RE: Status of DR 25-13 "Thoroughbred Car Wash" at 1299 N Pacific Hwy (Tax Lot051W08DB02400)

TRANSPORTATION REVIEW COMMENTS

SUBJECT: Woodburn Thoroughbred Express Car Wash Project #24150-001

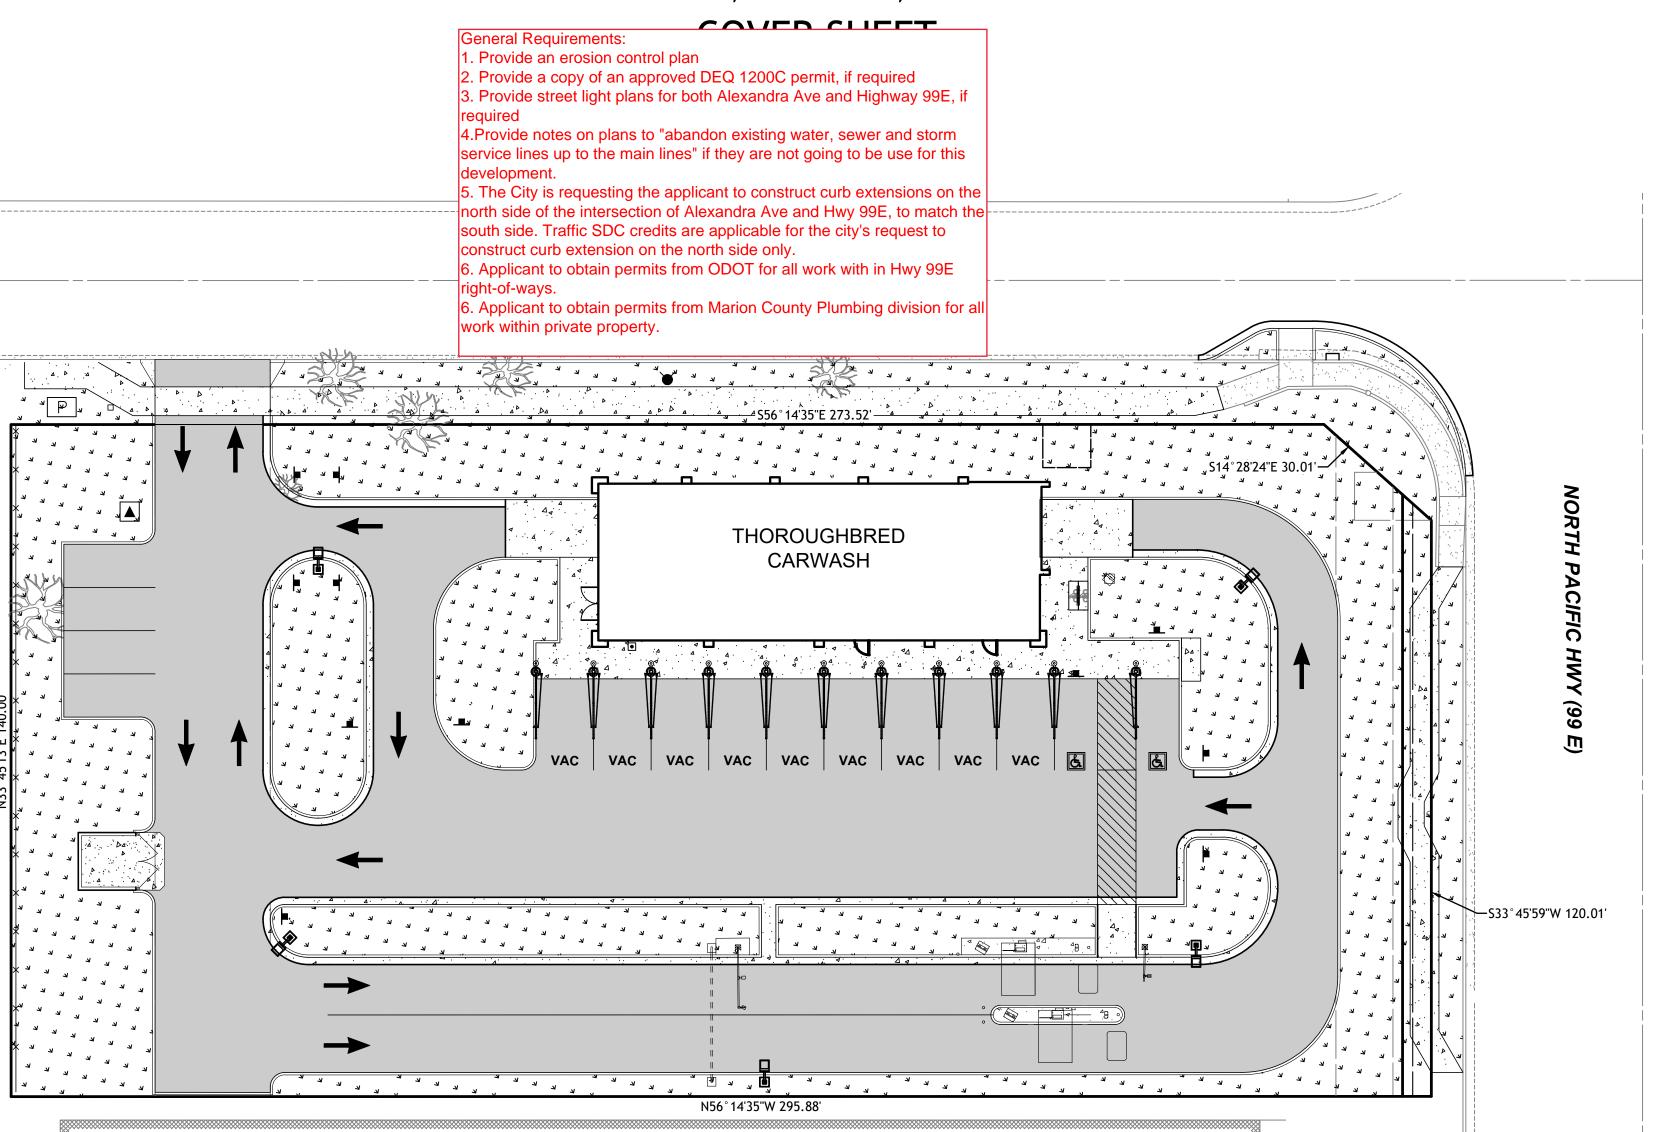
- Provide a Traffic Impact Analysis (TIA). The City uses a third-party transportation planning consultant, DKS Associates, for TIA reviews. Please refer to the attached memo from DKS and respond to the comments.
- Narrative: describe who Nick Ciero is to the property, provide context for architectural choices
- Respond to and revise plans per ODOT's comments.
 - Either realign the sidewalk along N. Pacific Hwy to either be entirely within the ROW dedication (not in the PUE), or be prepared to dedicate a permanent access easement or to dedicate more ROW in that location.
 - ODOT has suggested a revision to the curb bump out on Alexandra. (See image below) Be prepared to meet their requirements.

GRADING AND STORM DRAINAGE PLAN

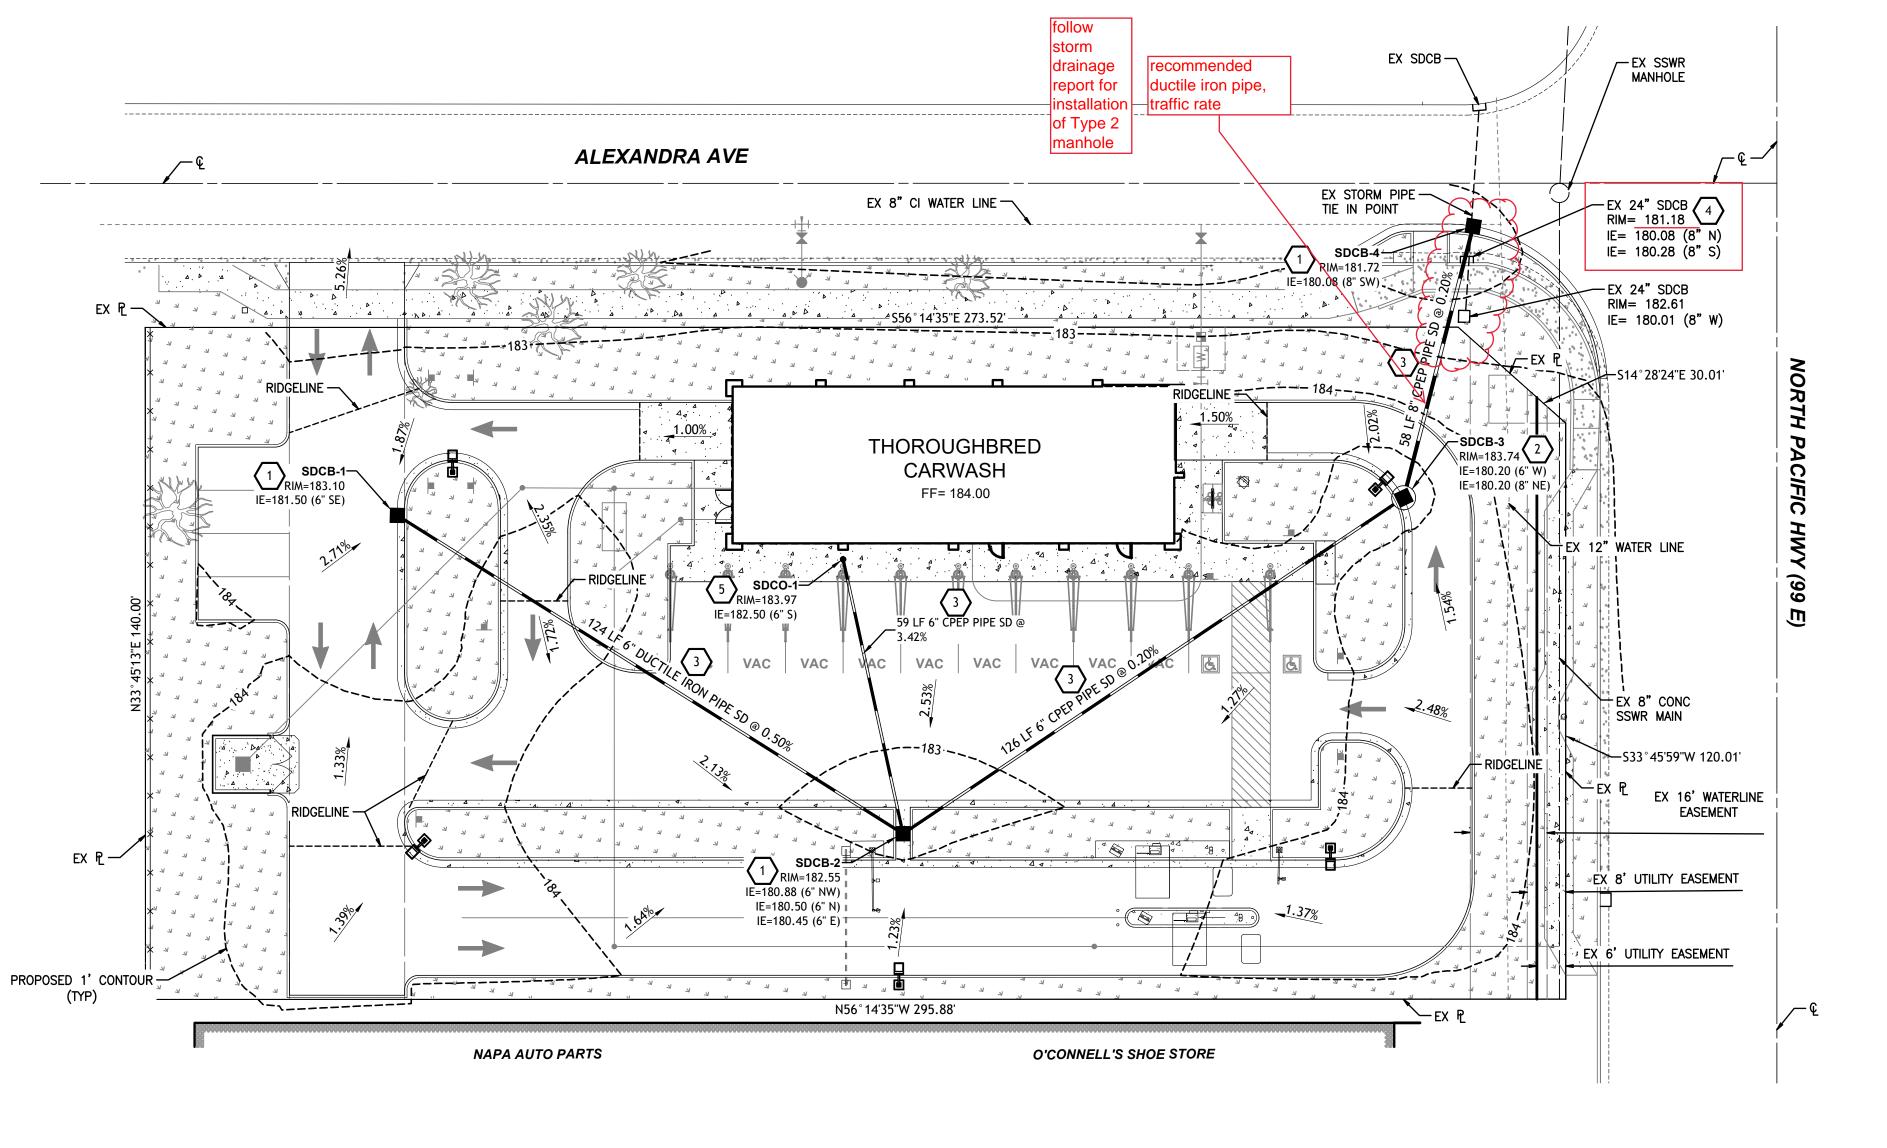
Provide an erosion control plan
- 5. CONTRACTOR TO OBTAIN ANY NECESSARY RIGHT-OF-WAY PERMITS IF REQUIRED FOR WORK SHOWN ON PLANS.
- 6. CONTRACTOR SHALL MATCH EXISTING ELEVATIONS AT ALL SAWCUT

linstall a type 2 manhole as per storm drainage report

PRELIMINARY UTILITY PLAN

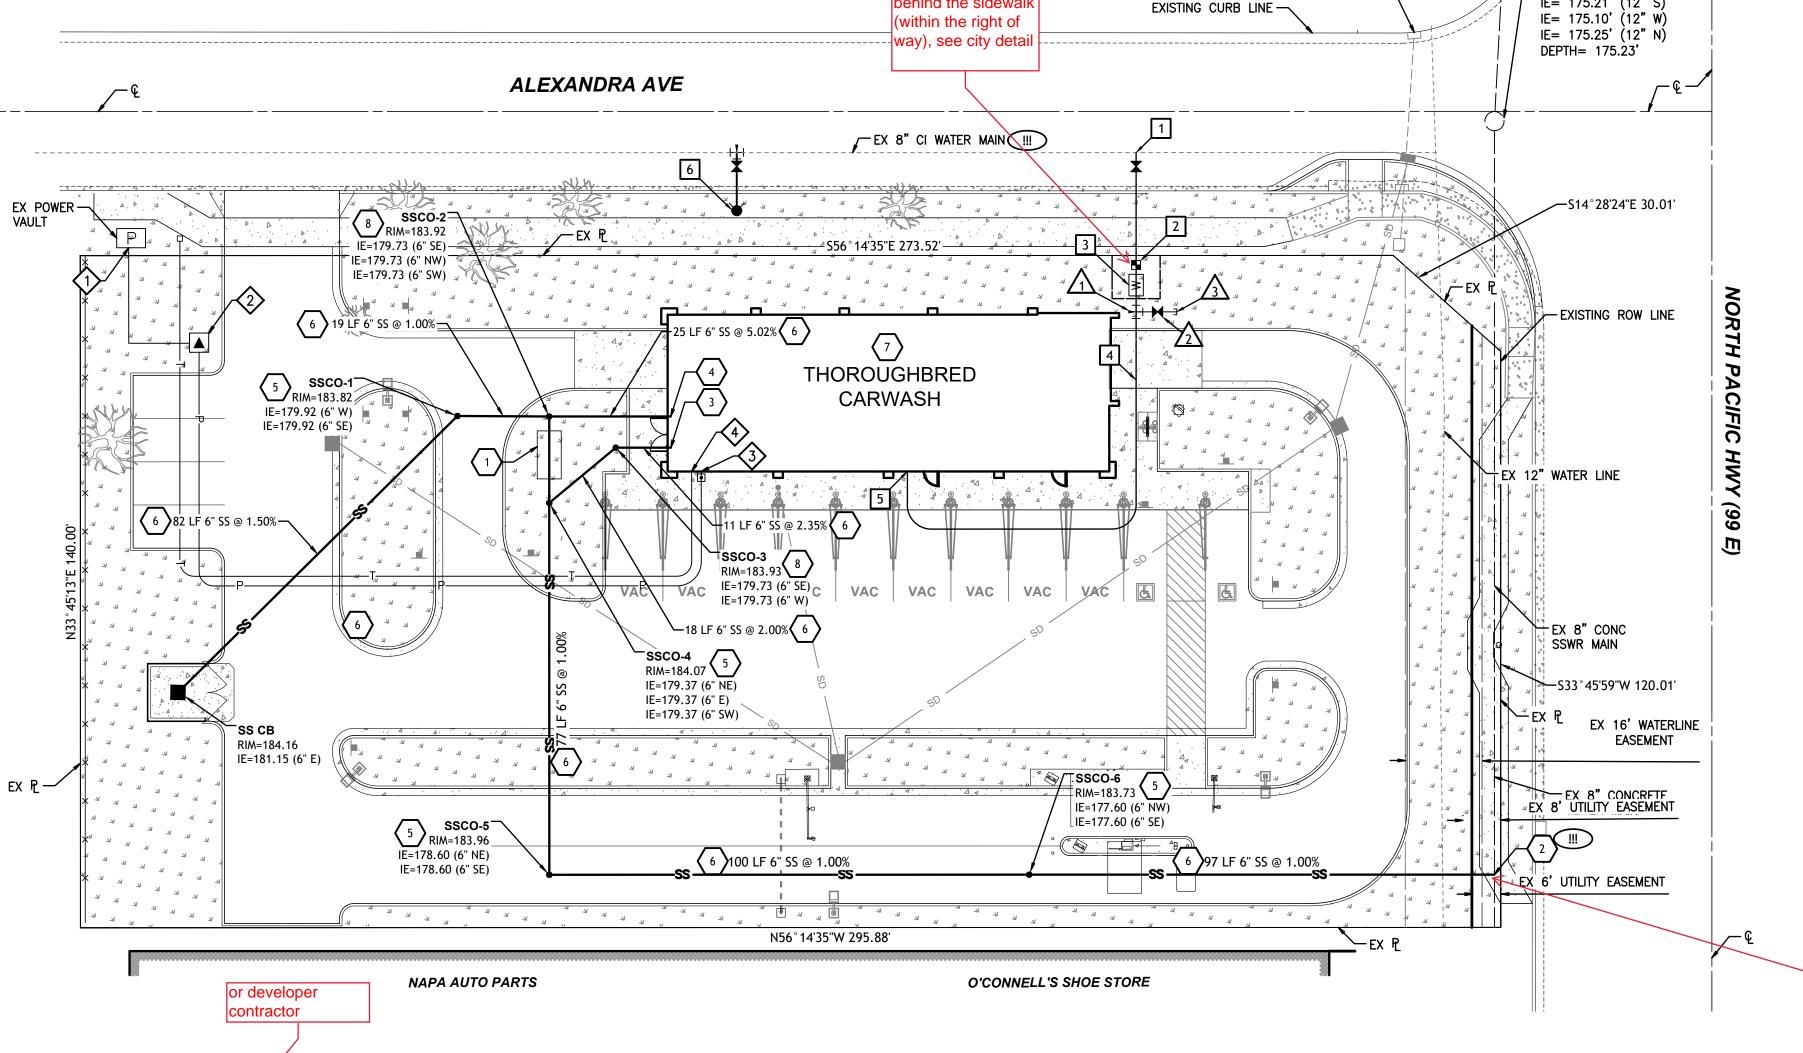
neter location

ehind the sidewall

- Pending review and approval by the 1. OLDCASTLE OIL/WATER 660-SA SEPARATOR TANK.
- city's wastewater coordinator. 2. CONNECT 6" SANITARY SEWER SERVICE TO EXISTING 8" CONCRETE SEWER MAIN, INVERT ELEVATION AS SHOWN IN PLAN VIEW, CONTRACTOR TO PROVIDE NECESSARY FITTINGS AND COUPLINGS TO MAKE CONNECTION. CONTRACTOR TO VERIFY LOCATION, CONDITION, AND DEPTH OF PROPOSED CONNECTION AND ENSURE POSITIVE DRAINAGE CAN BE ACHIEVED PRIOR TO CONSTRUCTION. REPORT RESULTS TO ENGINEER.

Install a cleanout

standard drawing

as per city's
